25th July 2018

MACQUARIE UNIVERSITY ARTS PRECINCT PROJECT

ACCESSIBILITY ASSESSMENT REPORT AMENDMENT s4.55

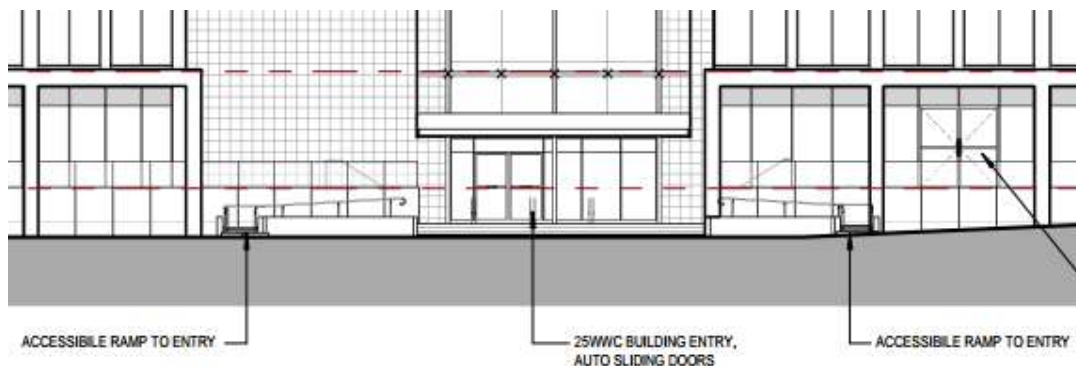
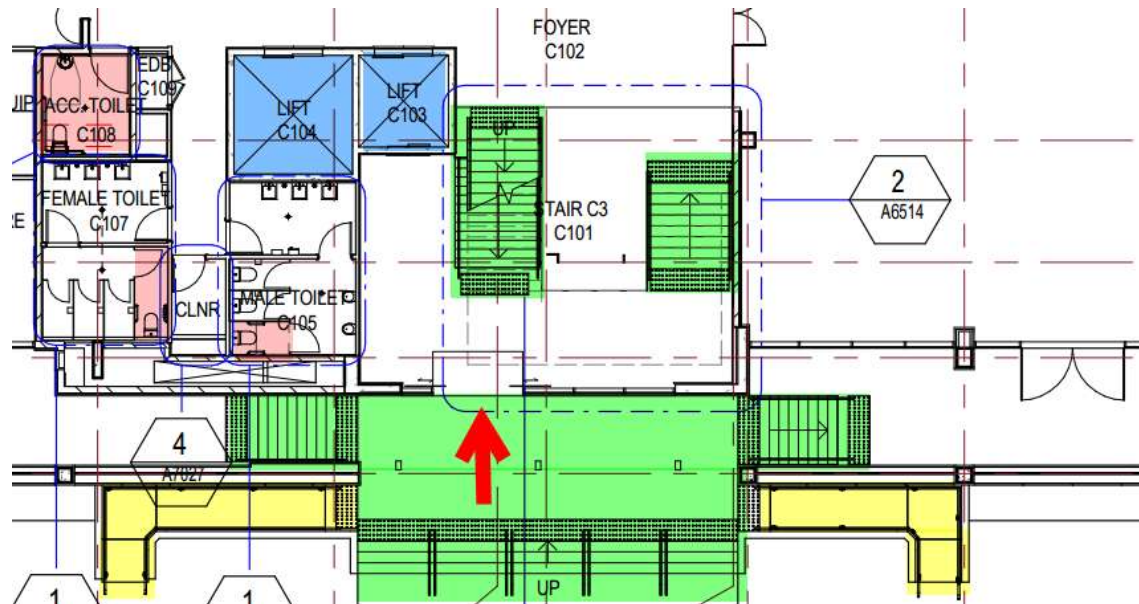
- 3.1. Access is required through at least 50% of entrances, including the principal pedestrian entrance/s to the Building. Note it is preferred that all entrances are accessible. The proposal indicates that accessibility through at least 50% of entrances is achievable. If incorrectly detailed these may restrict accessibility and present trip hazards.
- 3.2. The principal point of entry to the complex is at the southern face of Block C on Level 2. The external environment rises up to the entry level and main Foyer with an external stairway and 2 x external accessible ramps. From the main entrance landing, two additional stairways rise eastwards and westwards, respectively, to connect to corridors leading to Seminar Rooms to the west and Function/Temporary Exhibition Space to the east.

The building is entered through a double-leaf automated sliding doorway to a landing/lobby where 2 x internal stairways lead up to the Level 2 Foyer and down to the Ground Floor Foyer. A dedicated accessible passenger lift is located beside these internal stairways. The stairways and ramps will have all the features and dimensions as required by AS1428.1 and the passenger lift will be in accordance with AS1735.12. The issued drawings do not indicate RLs – detail to be provided.

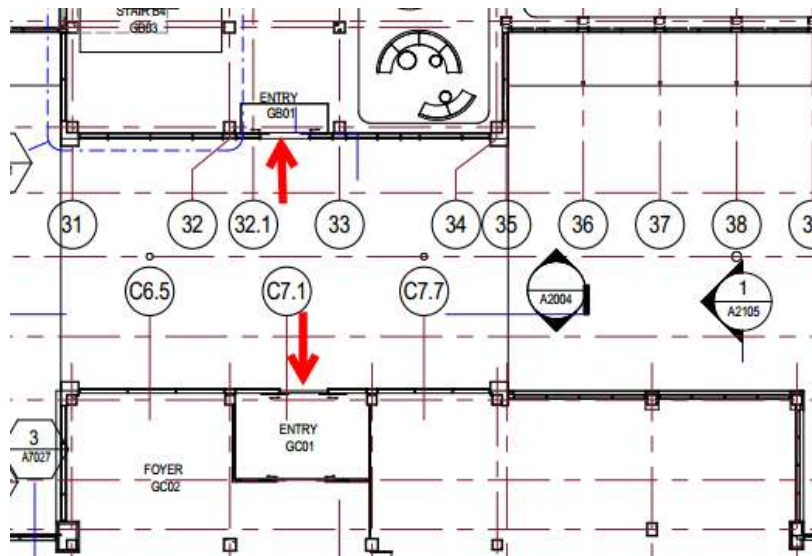
- 3.3. There are 2 x entrances facing north (Wallys Walk) that satisfy BCA D3 and AS1428.1.

The western entrance, between gridlines 02 and 18, has a rising walkway at 1:20 gradient (TGSIs not required) leading to a level landing that has a single automated sliding entry door on gridline H. Inside the doorway, the landing continues to a stairway with a mechanical platform lift.

The eastern entrance has a 1:21 gradient ramp and no doorway – leading to a row of seminar rooms, all with individual secure accessible doorways.

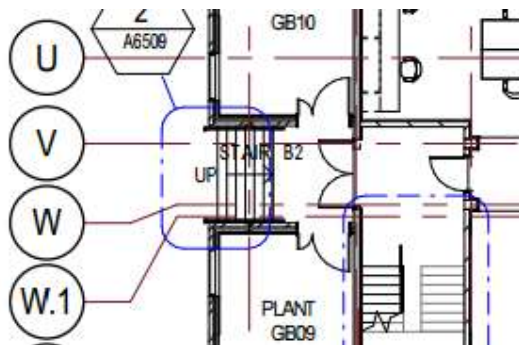
- 3.4. There are 2 x compliant entrances, facing each other, leading into buildings B and C, between gridlines 31 and 35. They have level landings and automated double sliding glass doors. Details to be provided prior to CC.

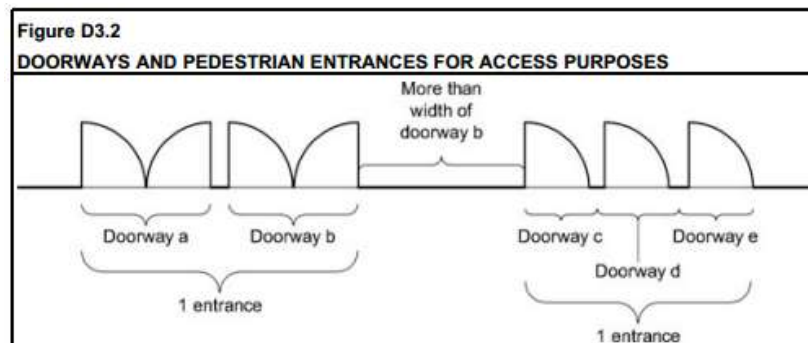
- 3.5. On the western end of Block B, there is a stairway connecting to 2 x plant rooms and into the accessible corridor. This doorway is not required to be accessible as this is an emergency egress only to the west from Building 25WWB.

- 3.6. The issued artist impression indicates the bridge link to/from building W5A, connecting at Level 1 over the open servicing area on Western Road. It appears as though there is a building entrance where the bridge meets Building A. Details to be provided prior to CC.

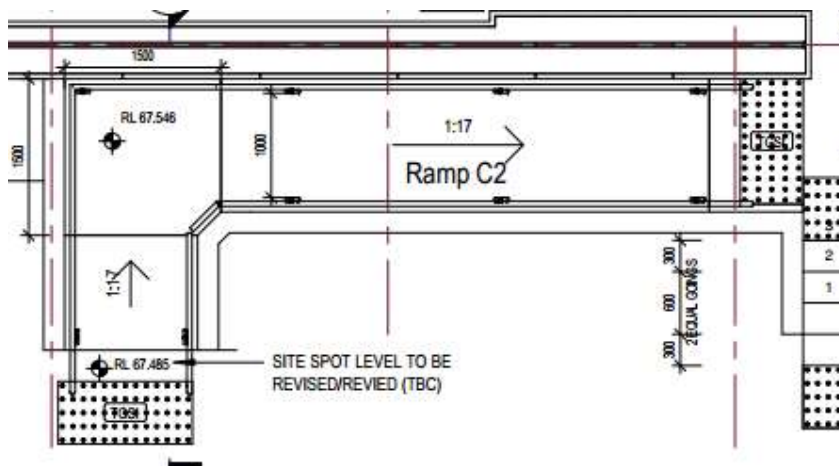
- 16.1. 2 x accessible pedestrian ramps are shown at the principal point of entry at Building C. These ramps show gradients below the maximum of 1:14, TGSIs top and bottom, handrails with extensions on both sides and a minimum width between handrails of 1000mm. The landings will be adjusted/increased to achieve 1500 x 1500mm clear of handrails and other intrusions.
